Record of Decision
Eighteenmile Creek Corridor Site
Operable Unit Nos. 1, 3, 4, 5 and 6
State Superfund Project
Lockport, Niagara County, New York
Site Number 932121

March 2010

DECLARATION STATEMENT - RECORD OF DECISION

OPERABLE UNIT LOCATION MAP		
DIVISION OF ENVIRONMENTAL REMEDIATION		
DATE: 08/12/09	DRAWING: Site Wide Map.dwg	
SITE NAME: EIGHTEENMILE CREEK CORRIDOR		FIGURE 2

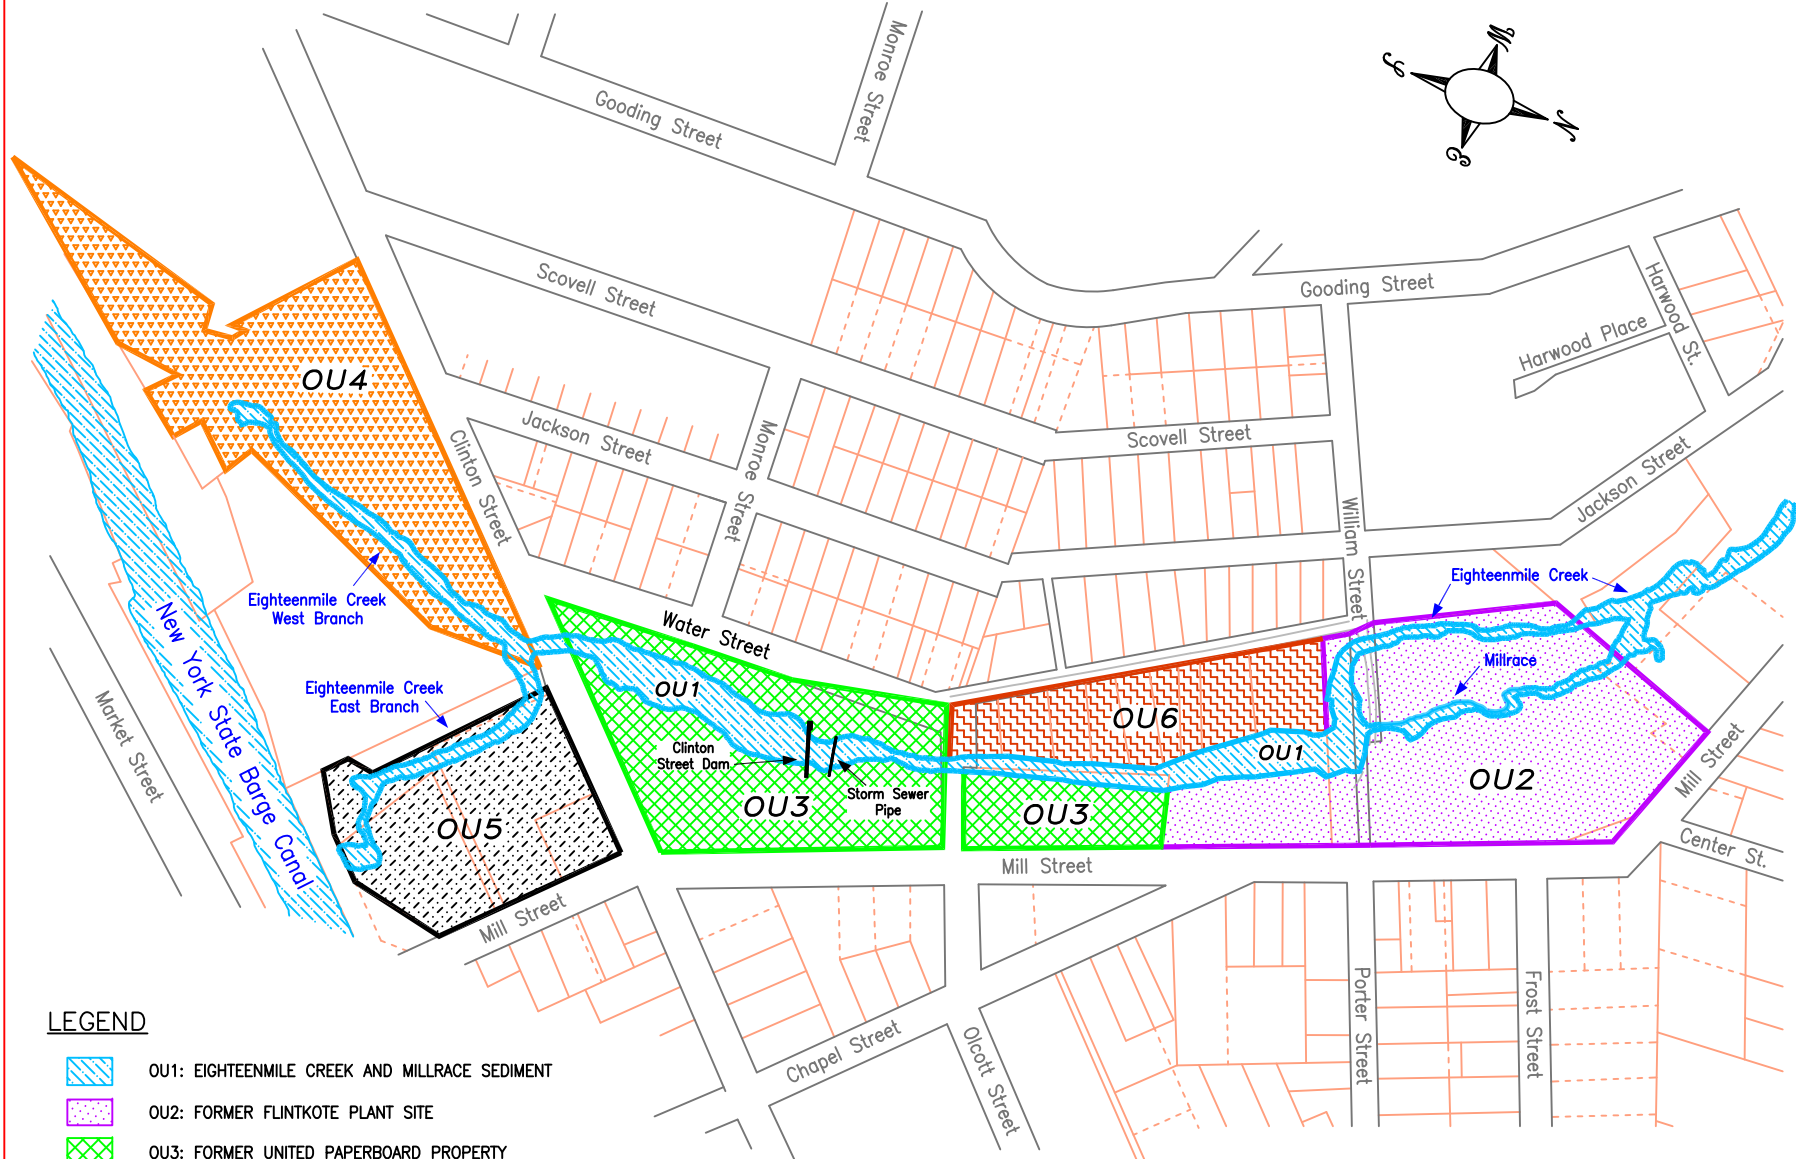
COMMENT 2: What is the extent of OU1? Will creek sediment be removed up to the trestle, or just to the edge of Flintkote?

RESPONSE 2: OU1 consists of approximately 4,000 linear feet of contaminated creek and

millrace sediment from the New York State Barge Canal to Harwood Street (Figure 2). The downstream limit (Harwood Street) is approximately 475 feet beyond the northern boundary of the Former Flintkote Property. The railroad trestle is beyond the extent of this remedial project.
